Company	Trenz Electronic GmbH
PCN Number	PCN-20250616
Title	TE0726-04 FTDI EEPROM Update
Subject	FTDI EEPROM
Issue Date	2025-06-16

Affected Product
TE0726-04

2.1 #1 FTDI EEPROM AMD-Licence key (MISC1).

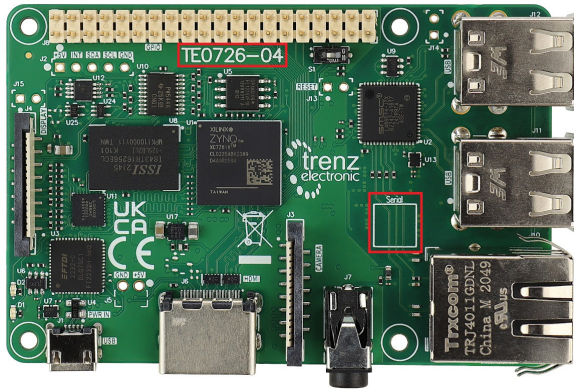
Type: Firmware change

Reason: Change according to FTDI programming method released by AMD with Tool Version 2022.2 and newer (UG980 - Chapter: Programming FTDI Devices for Vivado Hardware Manager Support).

Impact: AMD Licence key is compatible with AMD Tools greater and equal 2017.1 release. Programmer will be identified as Xilinx device with prefix 'TE' ,see [AMD FTDI JTAG Programmer#IdentificationofAMD/TrenzLicence](#)
